**FILE:** X020922.016 **DATE:** 14 May 2021

**SUBJECT:** Information Relevant To Item 7.7 – Project Scope - Pitt Street North Walking and Cycling Improvements

**Attachment A.** Sketch of Eastern Side Cycleway Configuration

## Location 03: Hunter Street

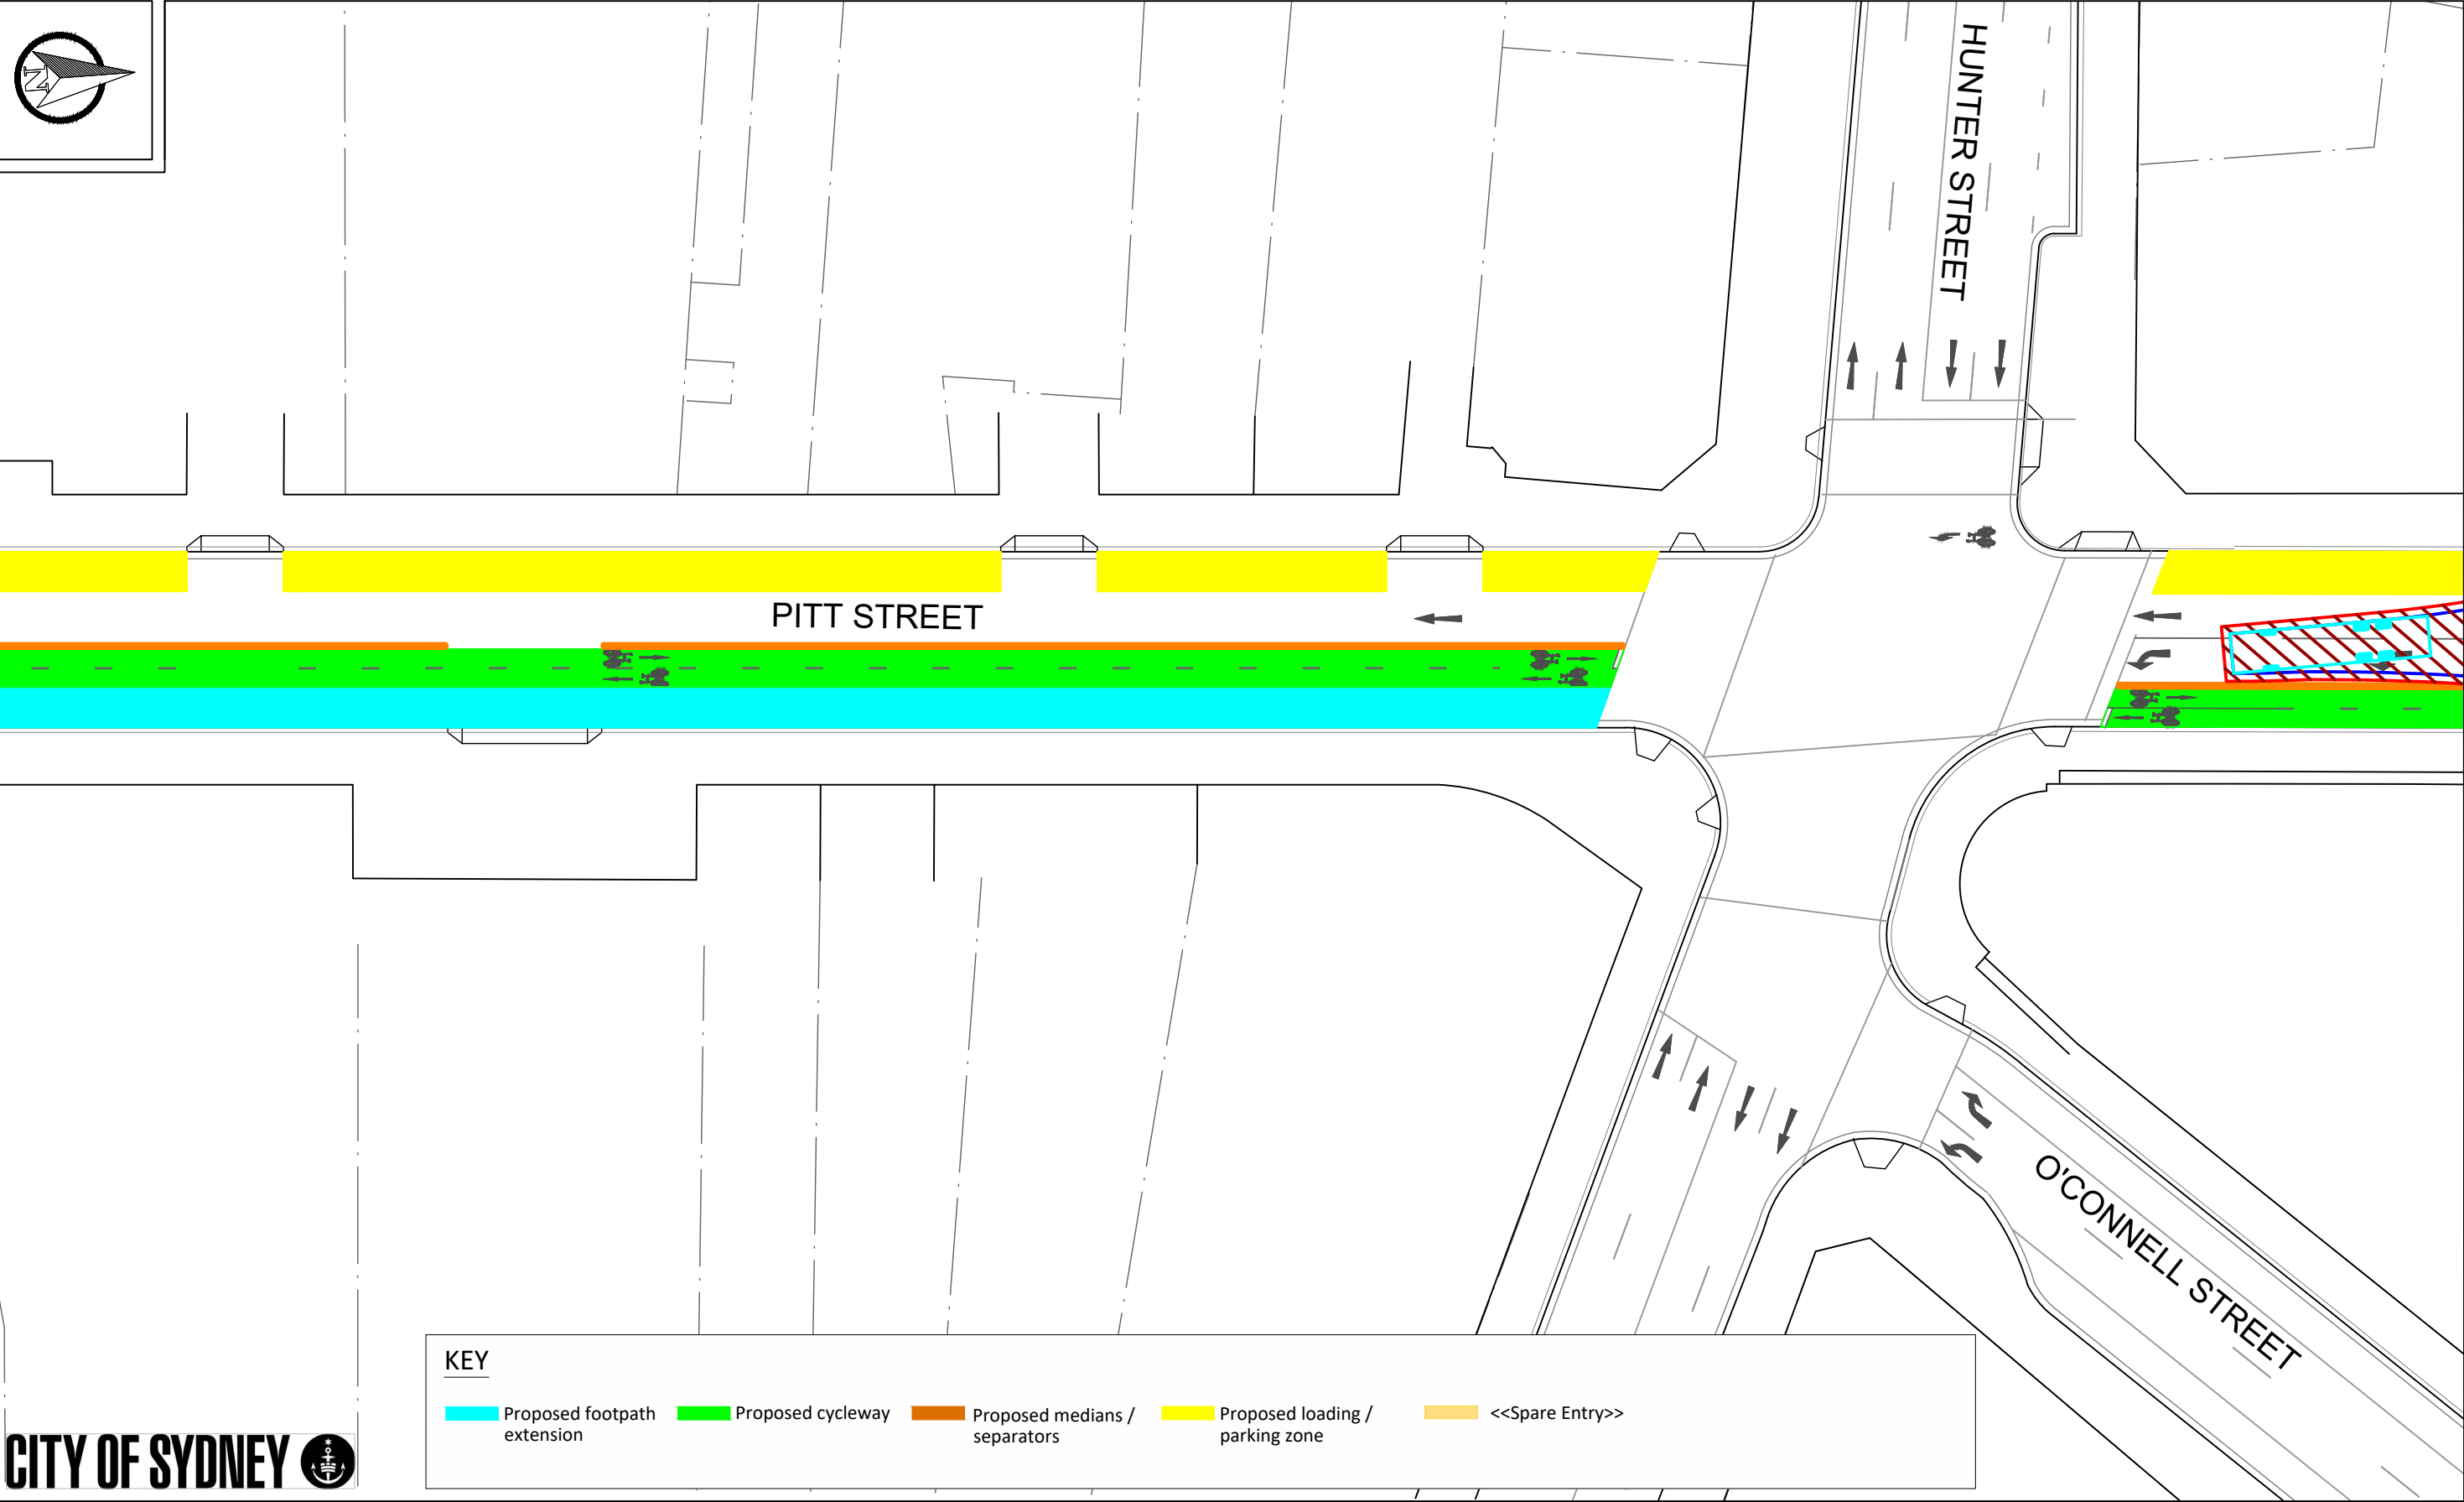
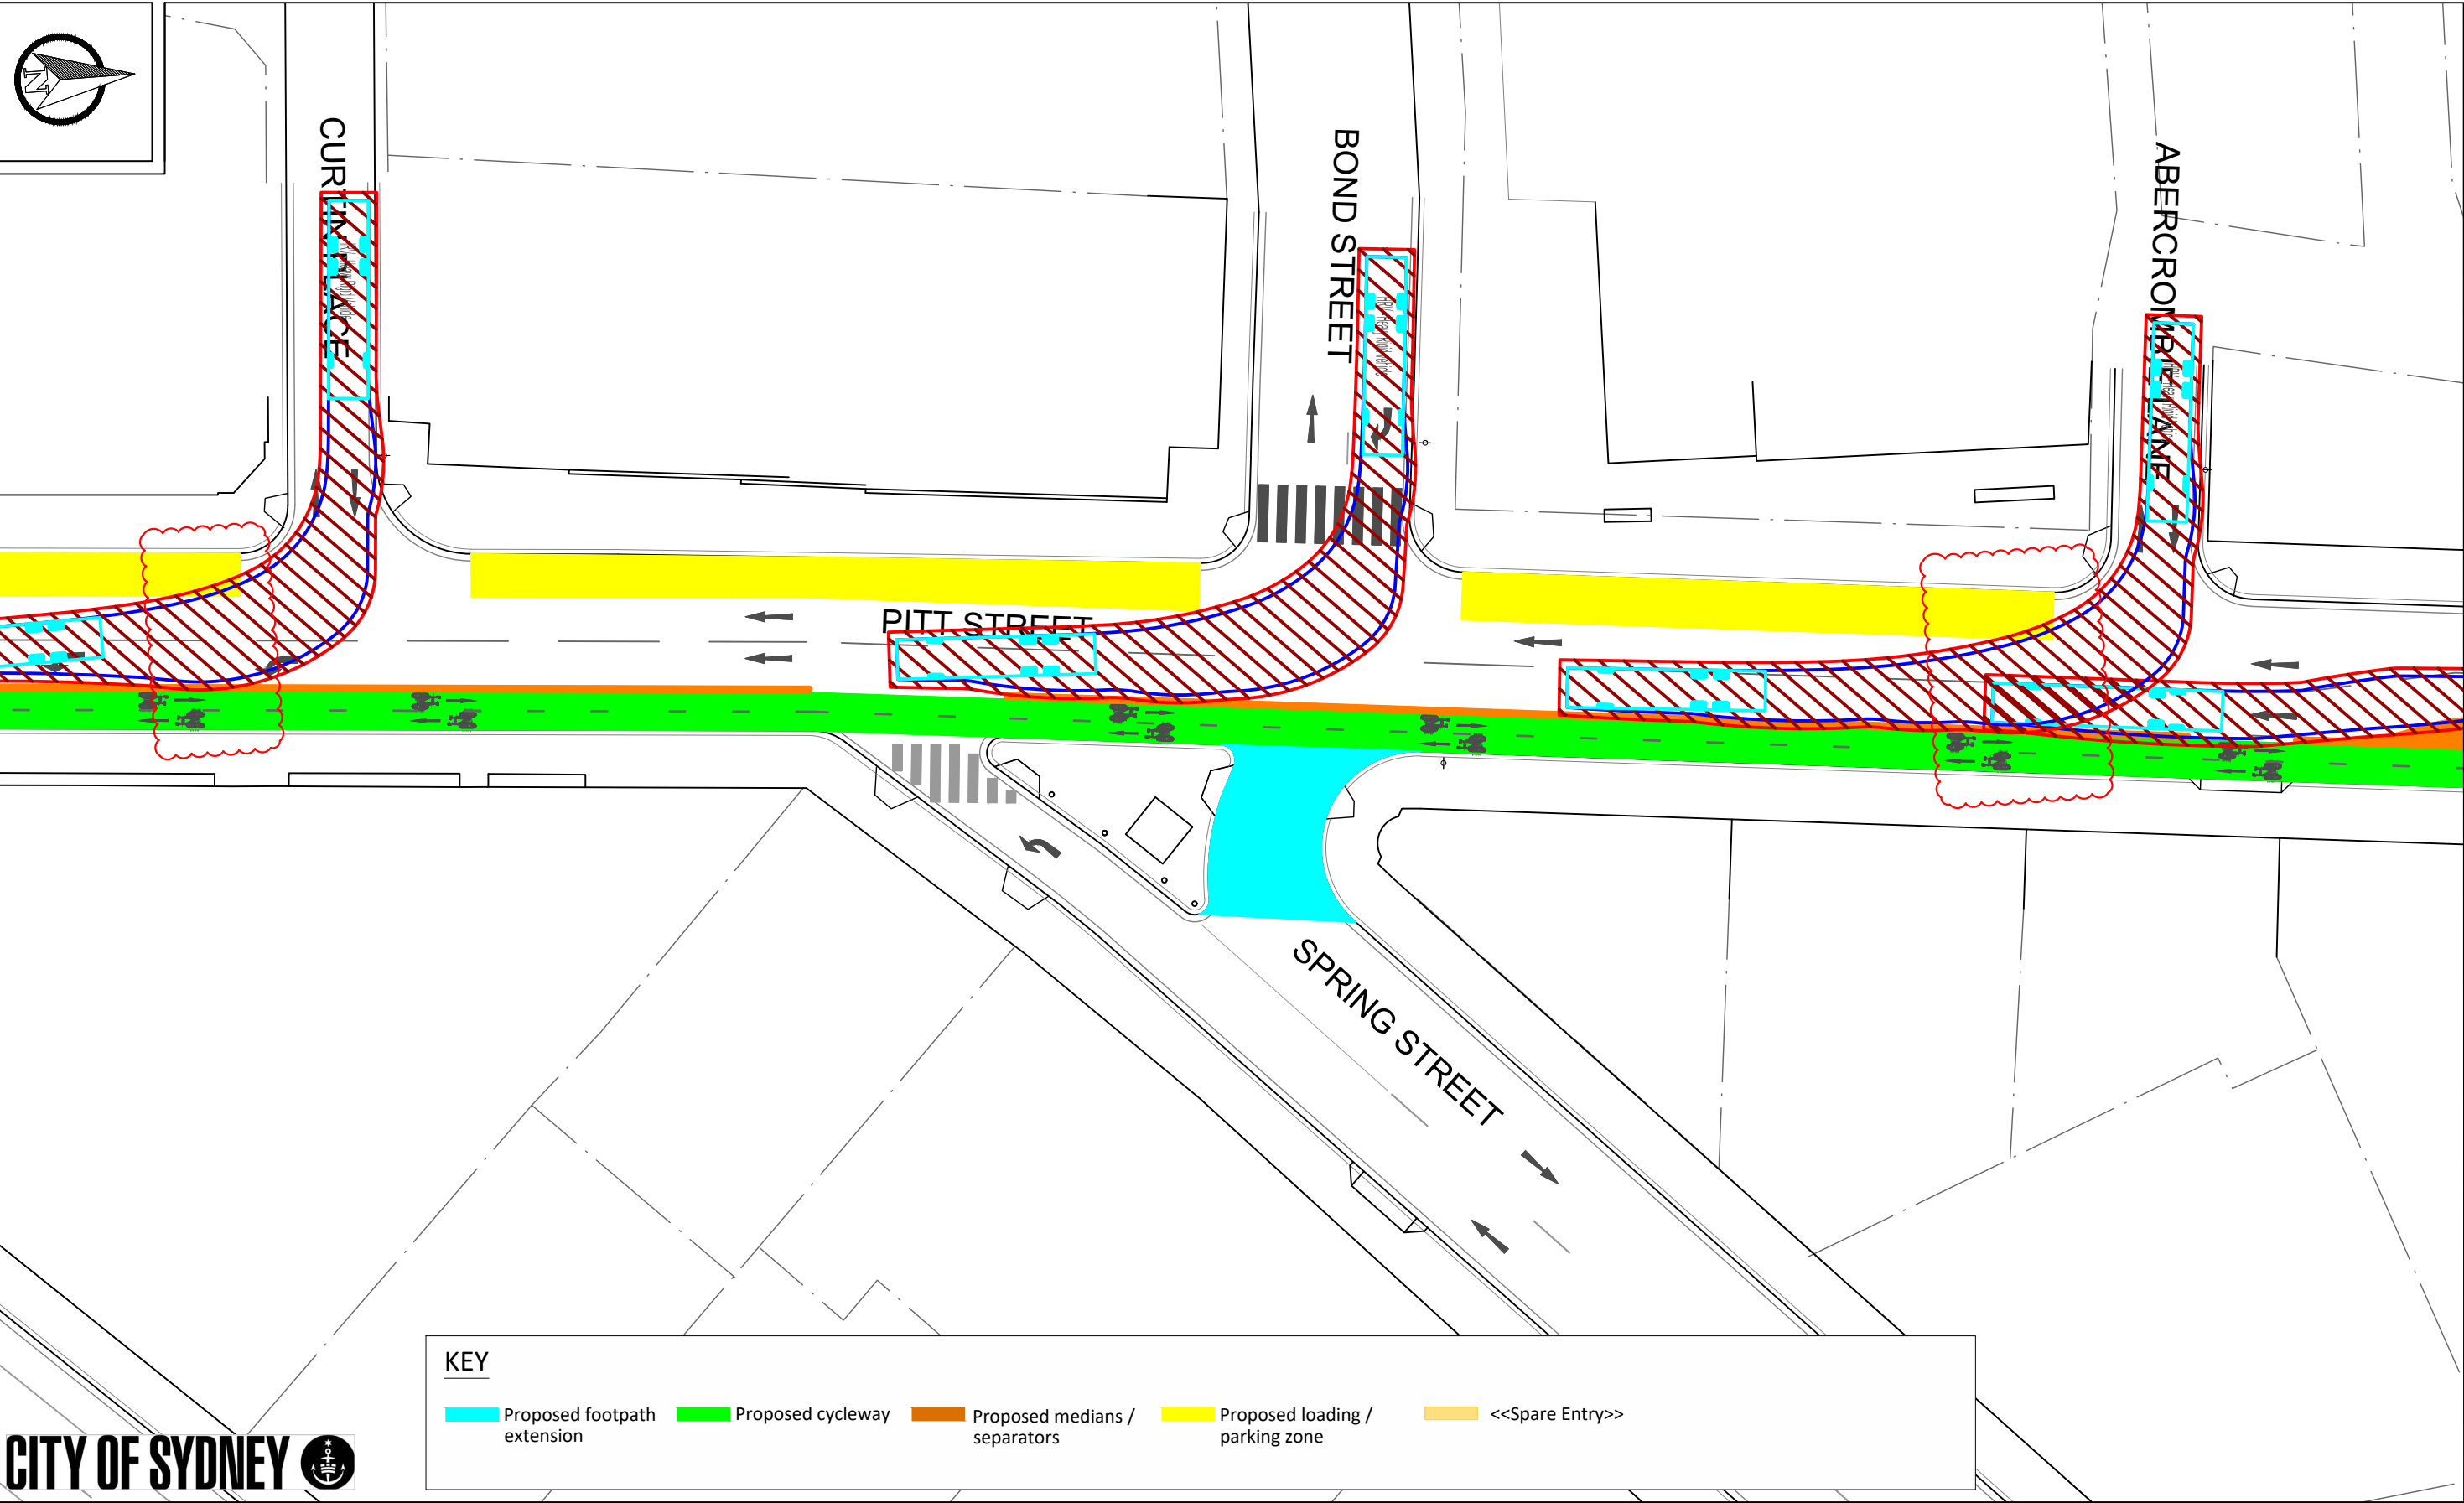
The Urbis submission requests the cycleway be moved to the eastern side of Pitt Street. Their primary contention is that the commercial car park driveways present a safety hazard to people riding when drivers exiting/entering car parks fail to look for bicycle riders. They also raised the following issues: cars queueing across the cycleway, misuse of the cycleway, pedestrian safety, delays in delivery times for businesses, unattractive materials, pedestrians crossing near Bond Street, and lack of bicycle parking.

The City has quickly prepared sketches of a configuration of the road space with an eastern side cycleway. This includes relocating the extra pedestrian area from the western side to the eastern side, and moving the parking on the eastern side to the western side (see Attachment A).

City staff, after reviewing the options again, recommend the cycleway should stay on the western side for road safety and efficiency of transport movement, as recommended in the original report to Committee.
